## STAFF REPORT AND FINDINGS OF FACT

TO: DESIGN REVIEW COMMITTEE

FROM: NANCY FERBER, PLANNER

ASTORIA CO OP  
DESIGN REVIEW SUBMITTAL  
APRIL 24TH, 2018

# SITE PLAN - OPTION B

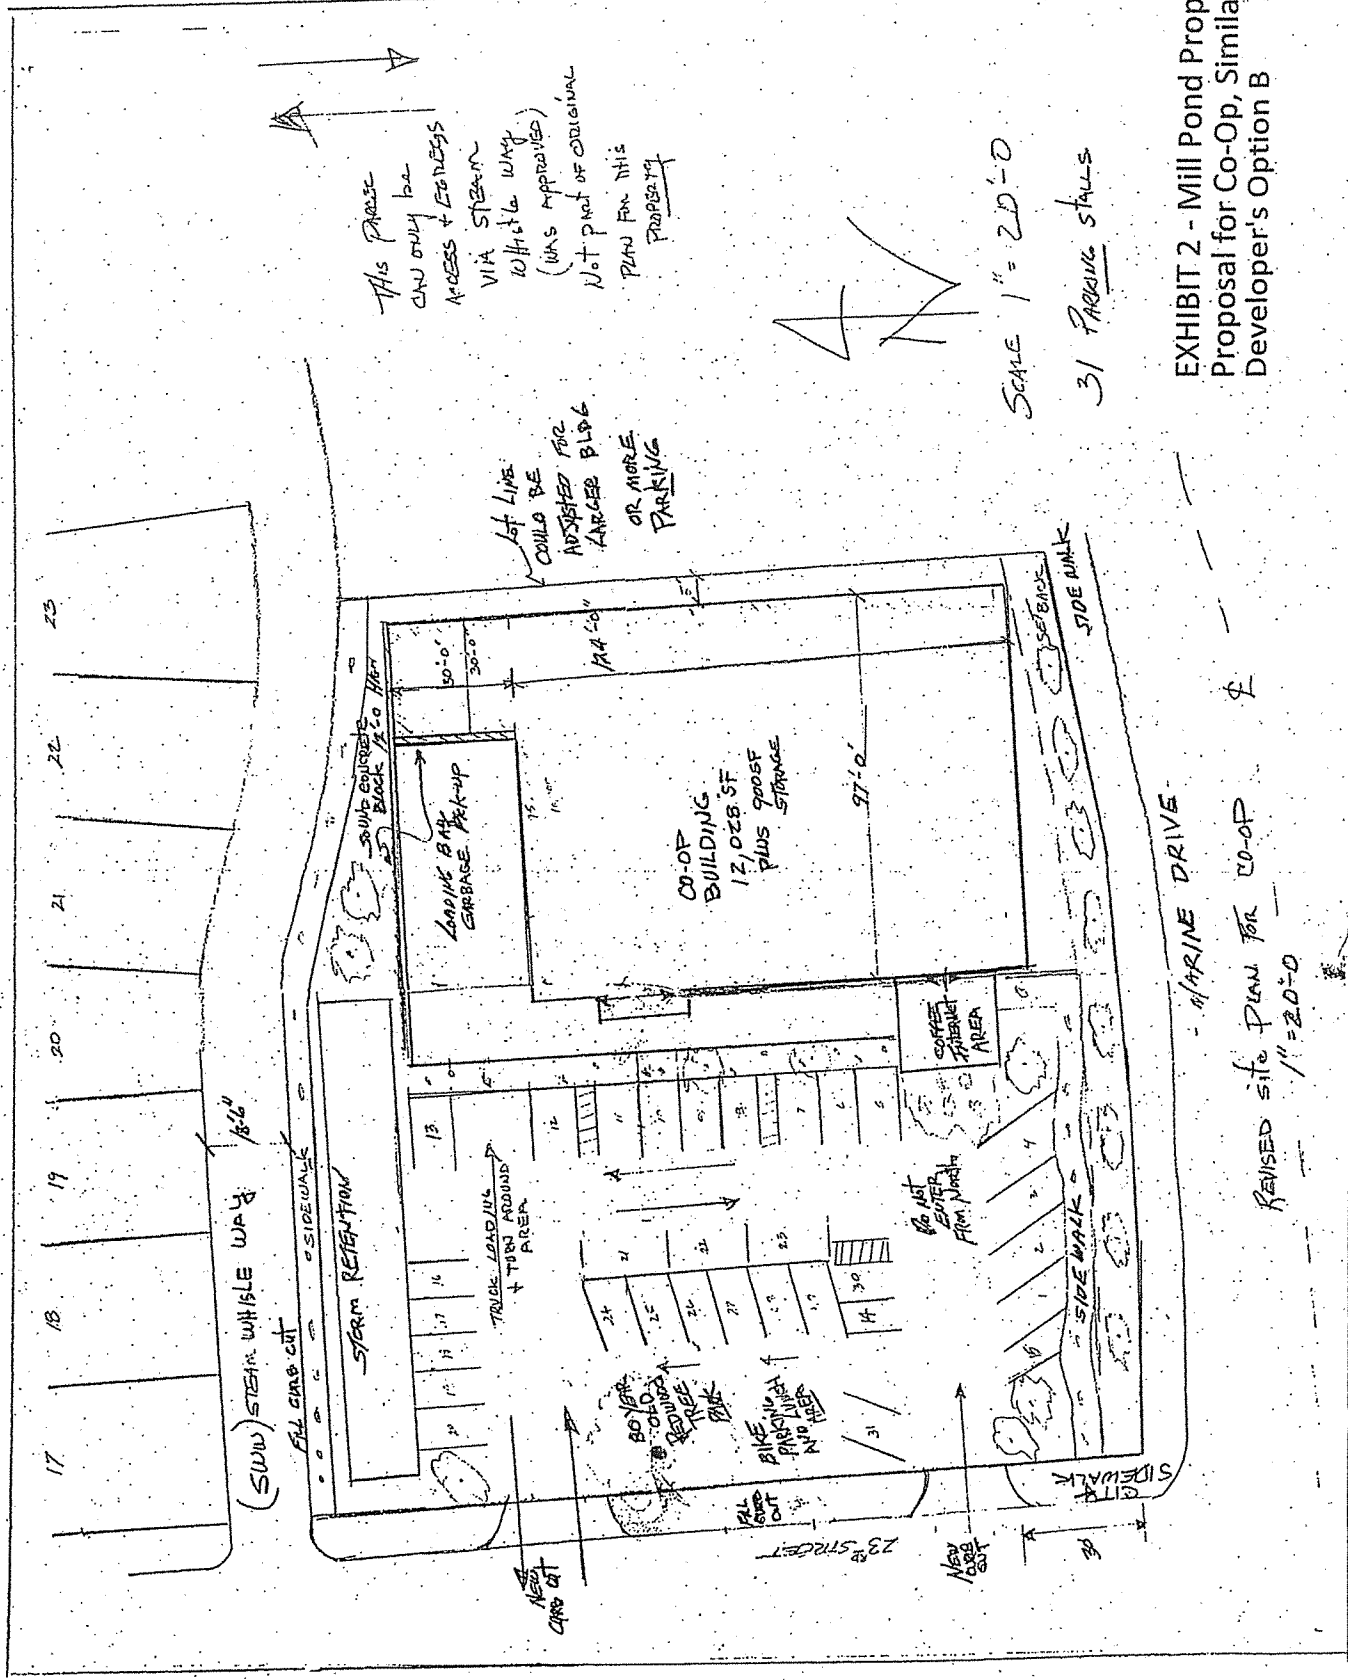
Due to our concern with the proposed Co-Op access via SWW, a Mill Pond resident created a revised site plan (Exhibit 2, p 4 of 7), which we find is VERY similar to Option B (page 3 of 7) as prepared by the developer, and both of these plans mitigate our objections to the "As Submitted" plan and the "Response to the Neighborhood" plan. We believe Option B also satisfies the Co-Op's requirements as submitted in their drawings. Please note that the Response to Neighborhood plan as submitted to the Design Review Committee (DRC) to "satisfy" the Mill Pond HOA Board is still not acceptable and was only approved, with objections, by the HOA Board after receipt of a January 25, 2018 e-mail from Don Vallaster threatening to send their request to mediation and binding arbitration (Exhibit 3, p. 5 of 7). The HOA Board always considered SWW access as unacceptable.

In summary, we wholeheartedly support Option B, which uses 23<sup>rd</sup> Avenue to access the Co-Op parking lot. Both our proposed plan and the developer's Option B plan are pedestrian friendly and visually consistent with the original vision of Mill Pond Village.

A201 | **1** | SITE PLAN  
SCALE: 1/16" = 1'-0"

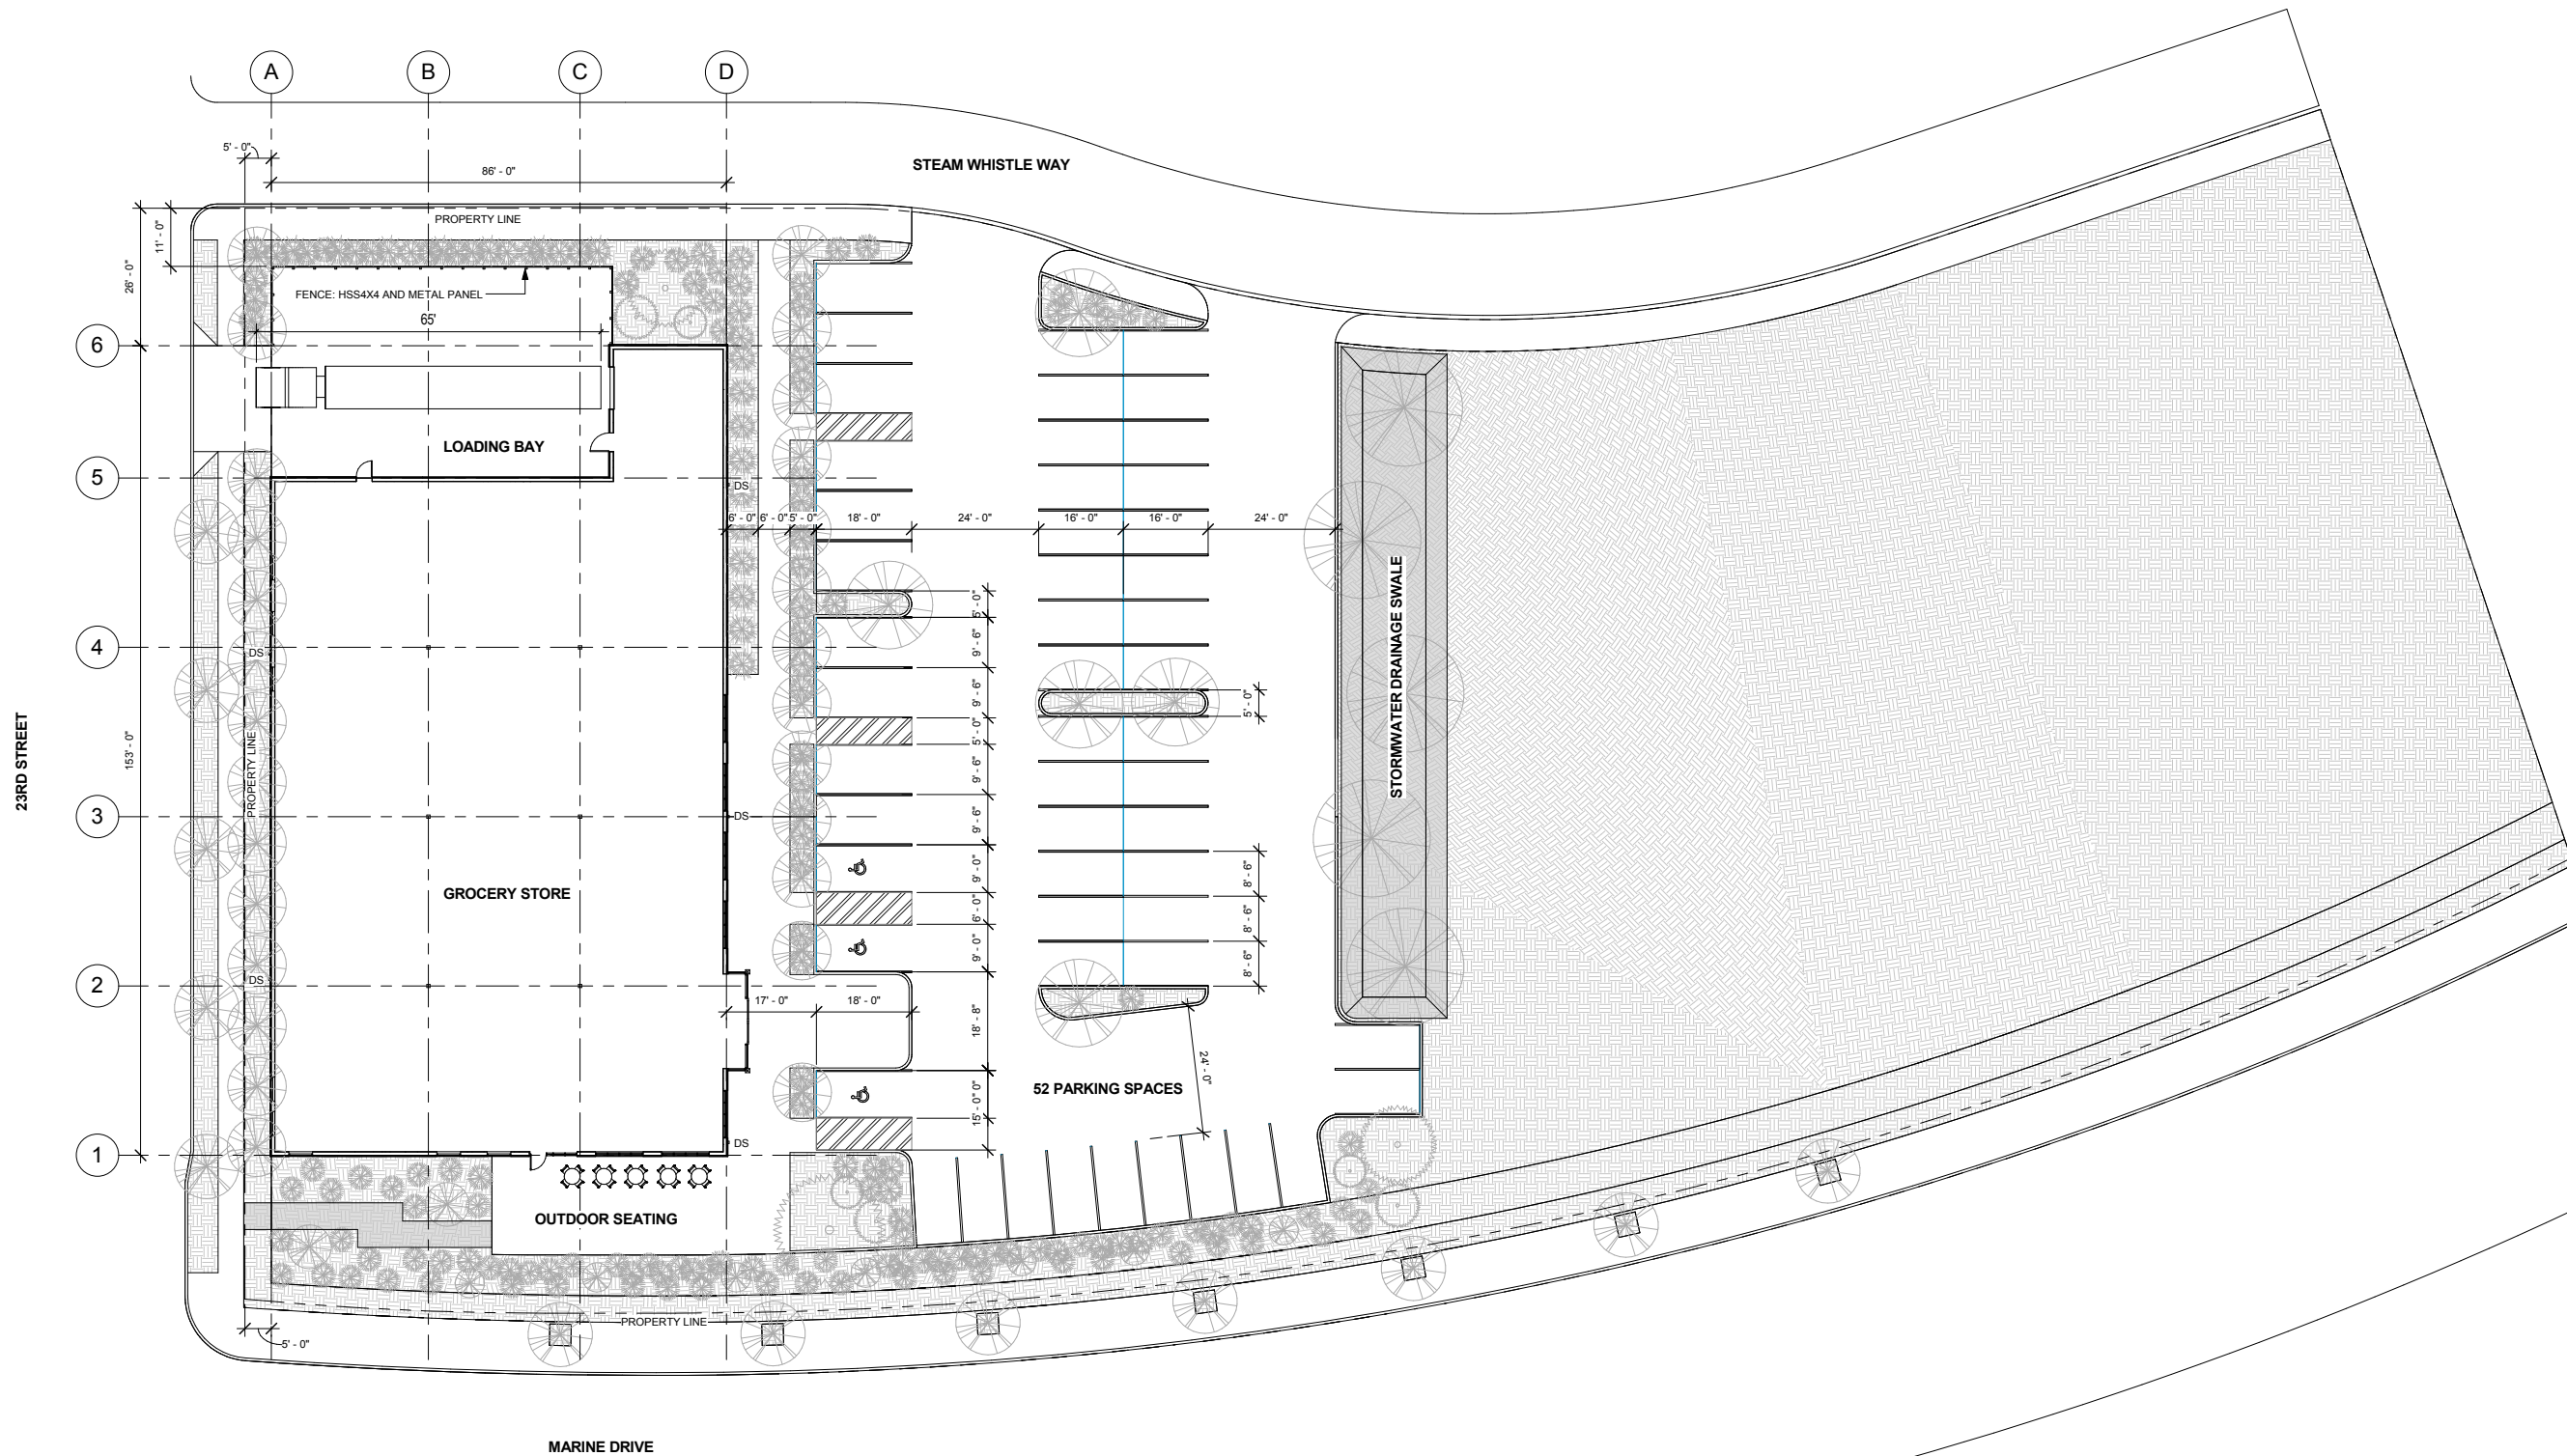
In reviewing the site plan for the proposed Co-op, it is clear that they are proposing all incoming and exiting traffic utilize Steam Whistle Way. This will clearly impact our properties, both in convenience and safety. In addition, we will have ADA requirements that will need to be considered, as this will be the primary egress for one of the owners. It is our belief that the Co-op site plan, with the traffic entrances as currently proposed, will have significant negative impact on the safety and livability of our properties.

**BACKGROUND:** The Mill Pond residents that live between 23<sup>rd</sup> and 27<sup>th</sup>, with access to their garages on Steam Whistle Way (SWW), have joined together to object to the current site-plans (both for the "As Submitted" plan and "Response to Neighborhood" plan) for the Astoria Co-Op, where the back of the Co-Op is sited on 23<sup>rd</sup> Avenue and/ entrance to the Co-Op parking lot is via Steam Whistle Way ("SWW"). Further, SWW has a long curve with limited visibility impacting those whose garages are along this street. Numerous Mill Pond residents have voiced concerns over the use of SWW to access the Co-Op parking lot. We are very concerned about the substantial increase in traffic on SWW and access in and out of our garages, resulting in a significant safety issue. The traffic study as presented by the Co-Op does not include any traffic study and impact on SWW nor on Mill Pond Lane. The existing traffic study only focused on Marine Drive and 23<sup>rd</sup> Avenue.

A301  
1 EAST ELEVATION  
SCALE: 1/8" = 1'-0"

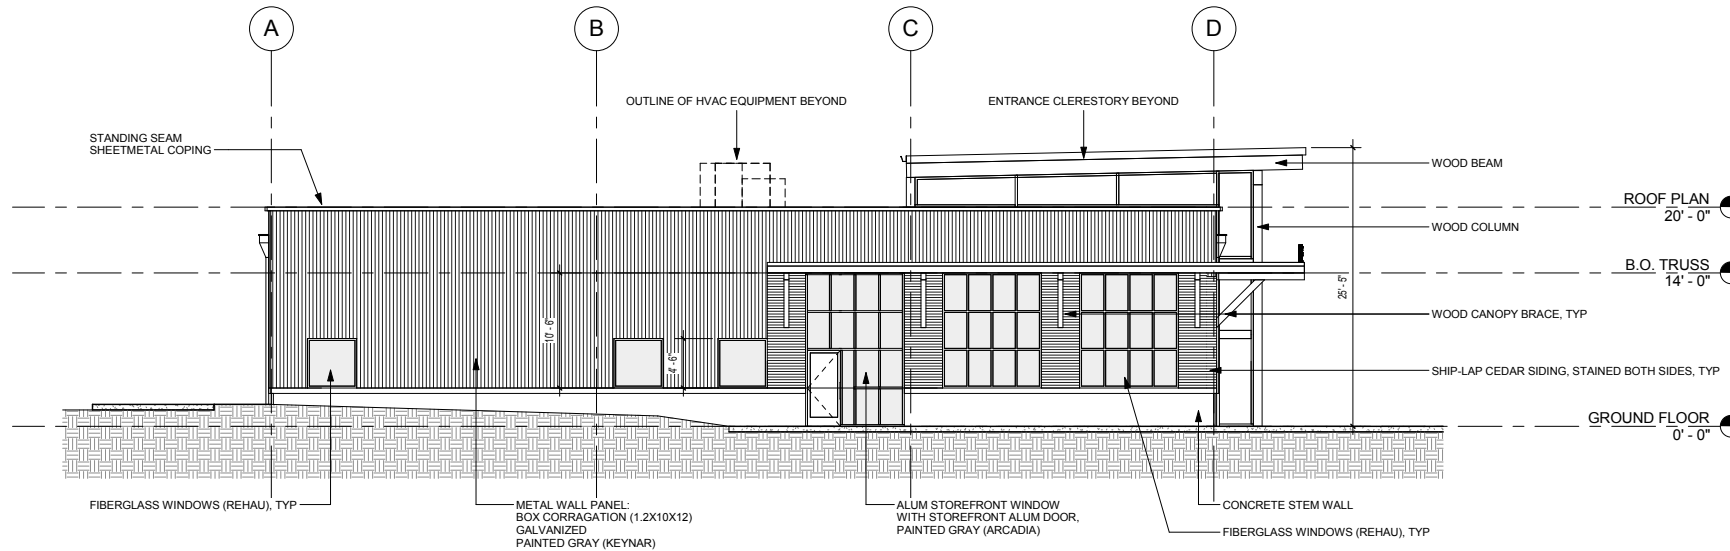
Two fixtures are proposed and shown to the right, and noted on the east elevation. The applicant shall clarify which fixtures are proposed for installation, and if they will be installed on any other facades. In an email dated 4-6-18, the applicant noted they will add four wall lights along the west wall. The applicant shall confirm where these lights will be located at the time of submitting a building permit.

8. Signage proposed will need a separate sign permit, and shall be reviewed against the Sign Ordinance, and compliance with the overlay zones.
9. The applicant has noted this lighting on the east elevation. The applicant shall clarify which fixtures are proposed for installation, and if they will be installed on any other facades including 4 lights located on the west façade as noted in an email dated 4-6-18.

A302  
2 WEST ELEVATION  
SCALE: 1/8" = 1'-0"

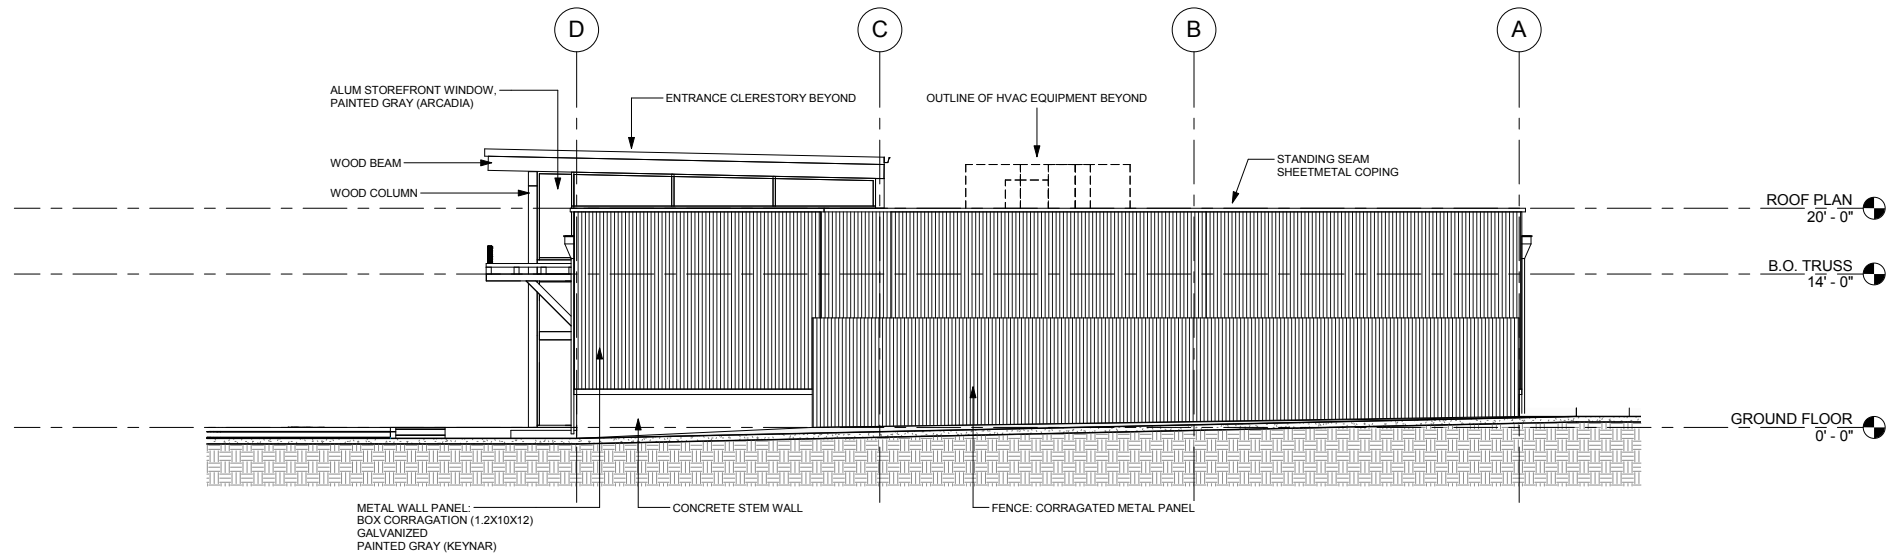
Additional details on the fiberglass windows on the west wall shall be submitted to confirm if they are single fixed windows or true divided.
